SSDA 7663 - TOYOTA SPARE PARTS WAREHOUSE AND DISTRIBUTION CENTRE - SITE 3B, OAKDALE SOUTH ESTATE

This letter provides a formal response to the matters raised in the submissions.

ATTACHMENT 1 ALTERNATE LAYOUT OPTIONS

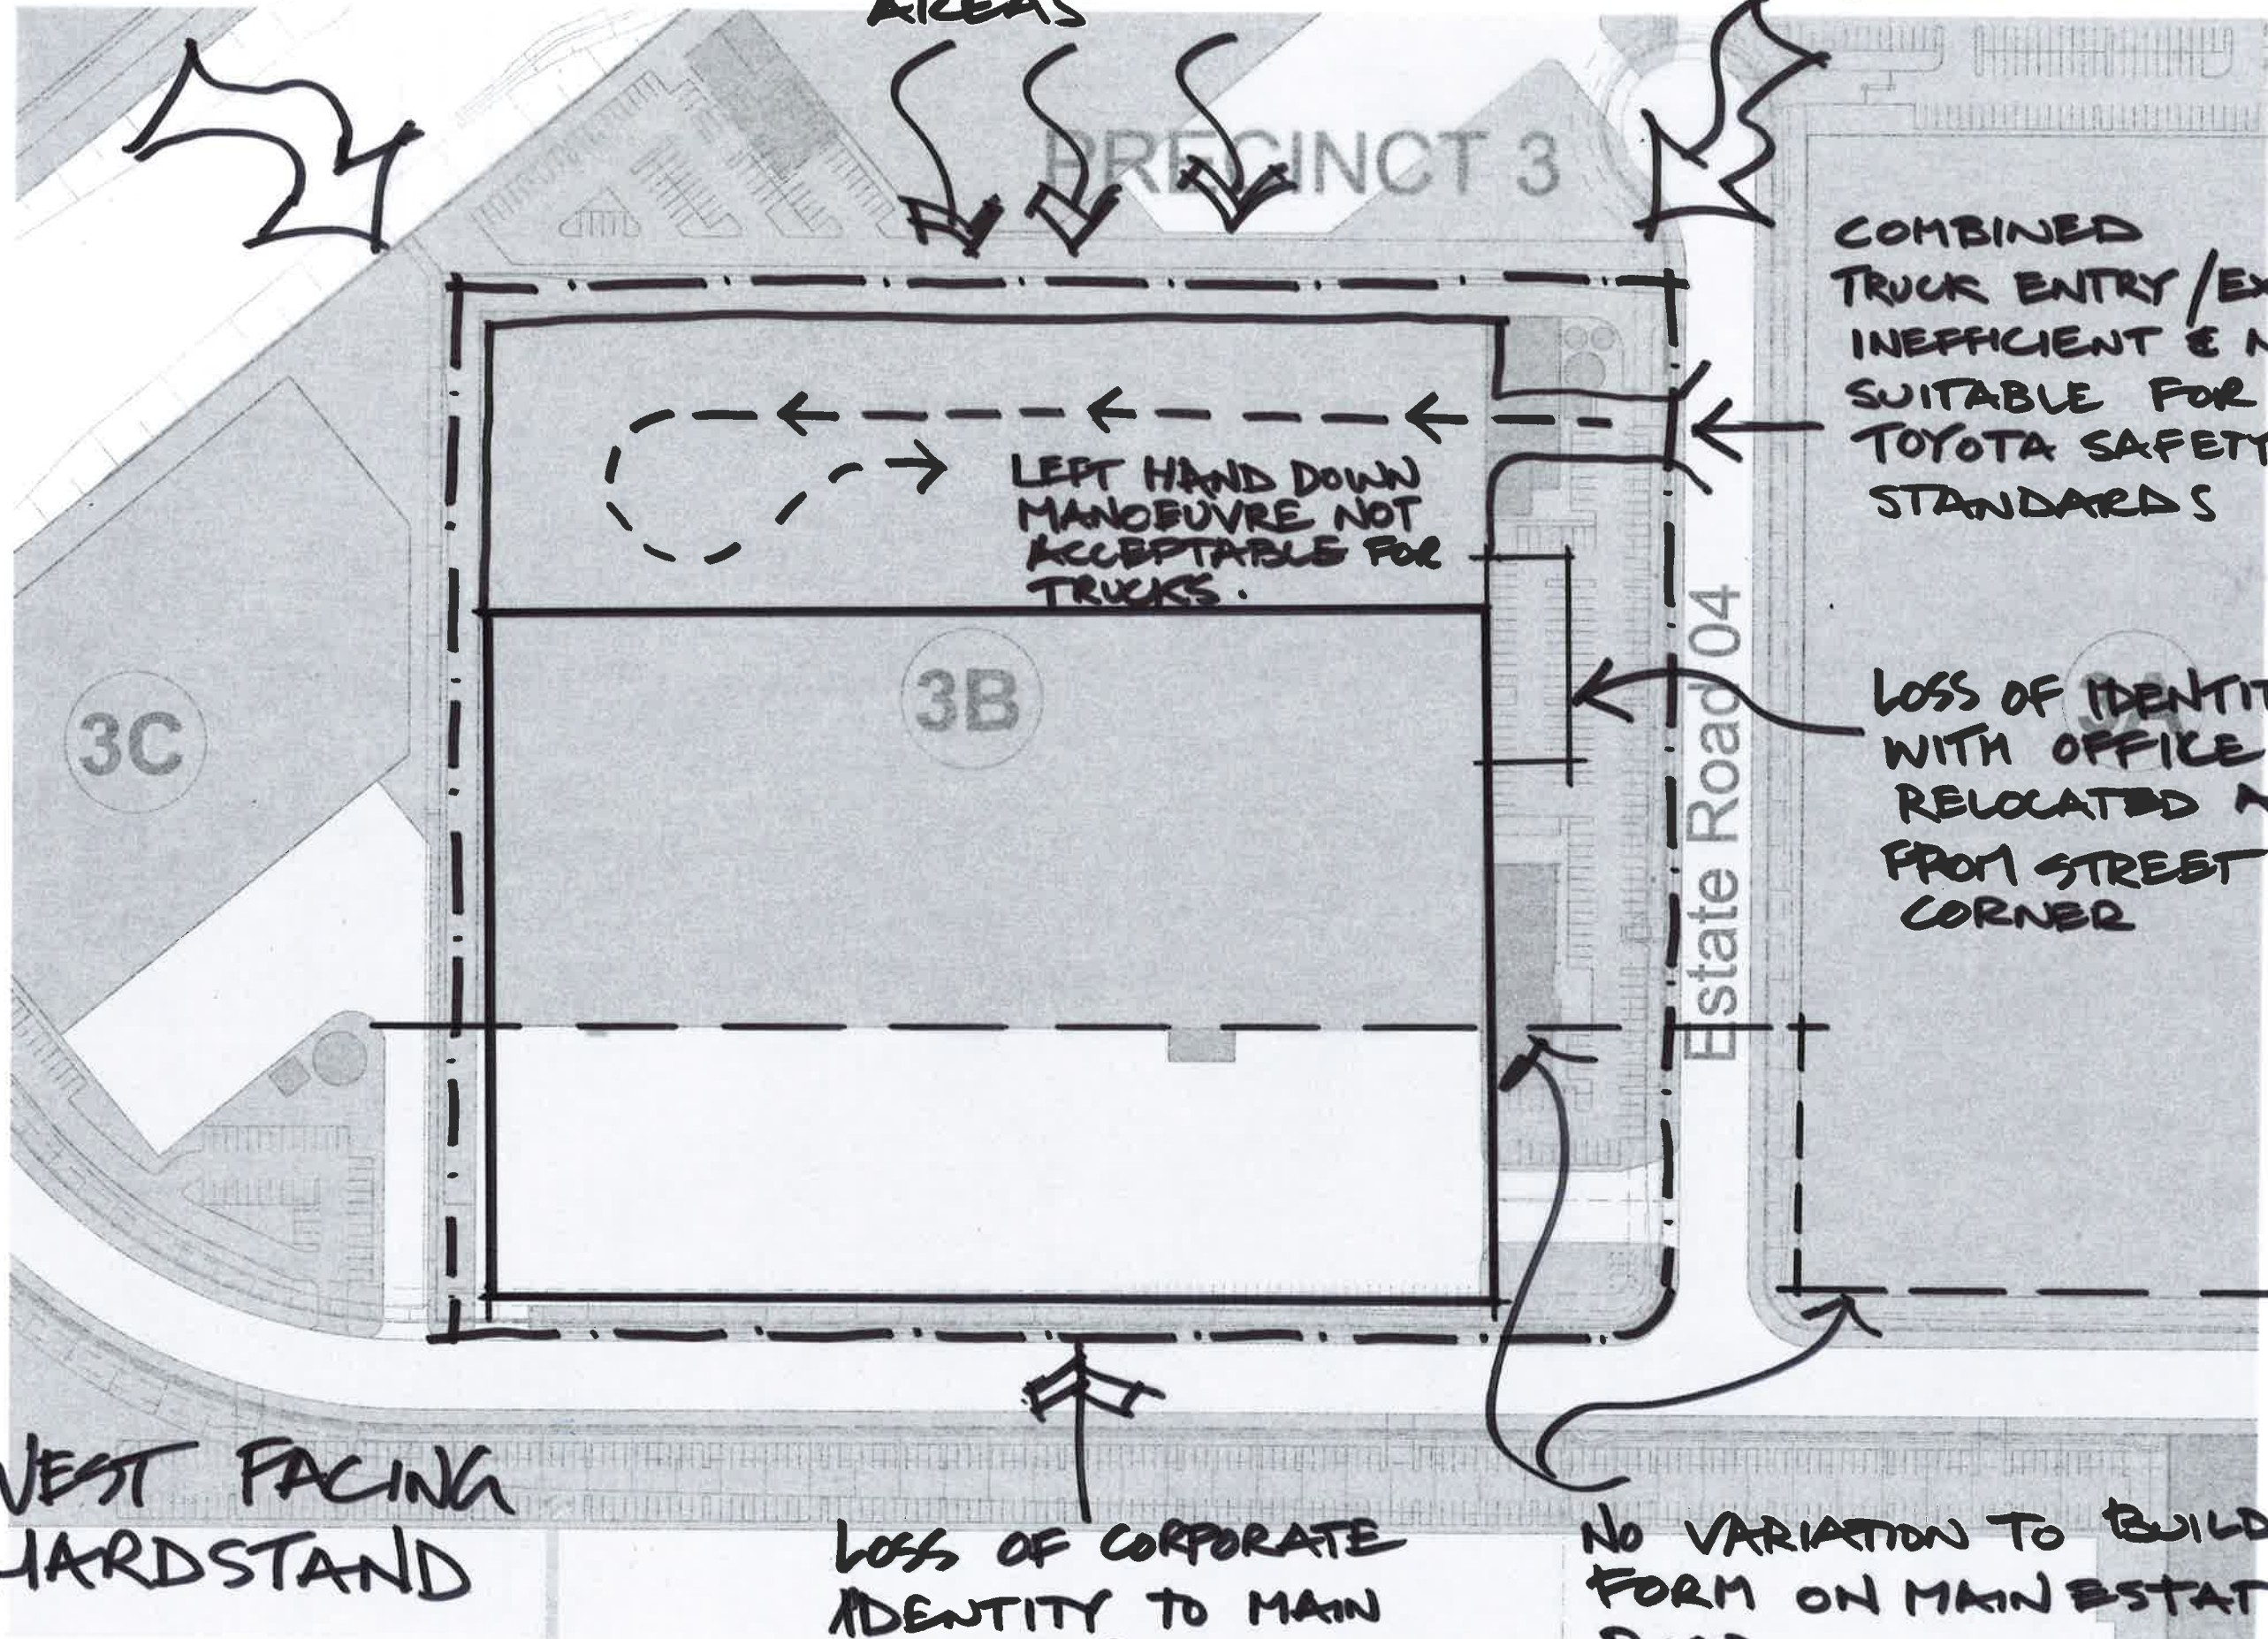
Matters Raised	Applicant consideration of matter/response
Department of Planning	
<u>Urban Design and Layout</u>	
<p>The primary frontage appears to be to Estate Road 4, and the loading dock occupies the secondary frontage to Estate Road 1, the most prominent frontage. Architectural/design control No. 5 of the Penrith Council Development Control Plan 2014 - Erskine Business Park requires loading docks to be located towards the rear of allotments and screened from view through physical and/or vegetation screening. Consideration should be given to relocating the loading dock to the western elevation.</p>	<p><u>Location of Building and Loading Dock</u></p> <p>The design of the Toyota Parts and distribution facility has been developed following extensive operational analysis and design development with the intent of achieving best practice across Toyota's global portfolio with respect to safety and operational efficiency.</p> <p>This process has been heavily informed by Toyota's well documented 'just in time' or 'lean' production systems (TPS) as well as the Toyota company commitment to 'Kaizan' (continuous improvement) following over 50 years of manufacturing cars in Australia.</p> <p>The fundamental design criteria for the orientation of the facility, including the location of the proposed loading docks has been informed by this operational analysis and includes:</p> <ul style="list-style-type: none"> • Warehouse proportions of 1:1.5 for maximum efficiency for movement and storage of parts in the warehouse and separation of man / machine for employee safety.

<p>The Department has some concerns due to these unresolved urban design matters. As the Oakdale South Estate is in its early stages of development it is important to set a positive precedent for future warehousing developments. By encouraging warehouse buildings that address primary frontages, activate streetscapes, provide architectural interest and reduce</p>	<ul style="list-style-type: none"> • The proposed buildings are operational facilities and while active frontages are sought and achieved where possible within the OSE, the operational requirements of the end-users have necessarily been prioritized to ensure that the facility can function in the manner required. Several alternative master plan options were considered however the

In response to DP&E comments, a justification of the proposed site layout is discussed in the following section. This justification is accompanied by a detailed options analysis at **Table 1** and illustrated in the plans at **Attachment 1**.

An options analysis has been undertaken to demonstrate the factors considered in the final orientation of the proposed warehouse. These options are illustrated at **Attachment 1**

STRONG WINDS IMPACTING
DOCK FACE.

INCREASED SOLAR GAIN
TO WESTERN OPERATIONAL
AREAS

WARM NORTH WEST
WINDS IMPACTING
DOCK FACE.

① WEST FACING
HARDSTAND

LOSS OF CORPORATE
IDENTITY TO MAIN
ESTATE ROAD

NO VARIATION TO BUILDING
FORM ON MAIN ESTATE
ROAD

COMBINED
TRUCK ENTRY/EXIT
INEFFICIENT & NOT
SUITABLE FOR
TOYOTA SAFETY
STANDARDS

LOSS OF IDENTITY
WITH OFFICE
RELOCATED AWAY
FROM STREET
CORNER

INCREASED SOLAR IMPACT
ON WEST FACING OFFICE
FACADE

WARM NORTHWEST
WINDS IMPACTING
OPERATIONAL
AREAS ON
DOCK FACE.
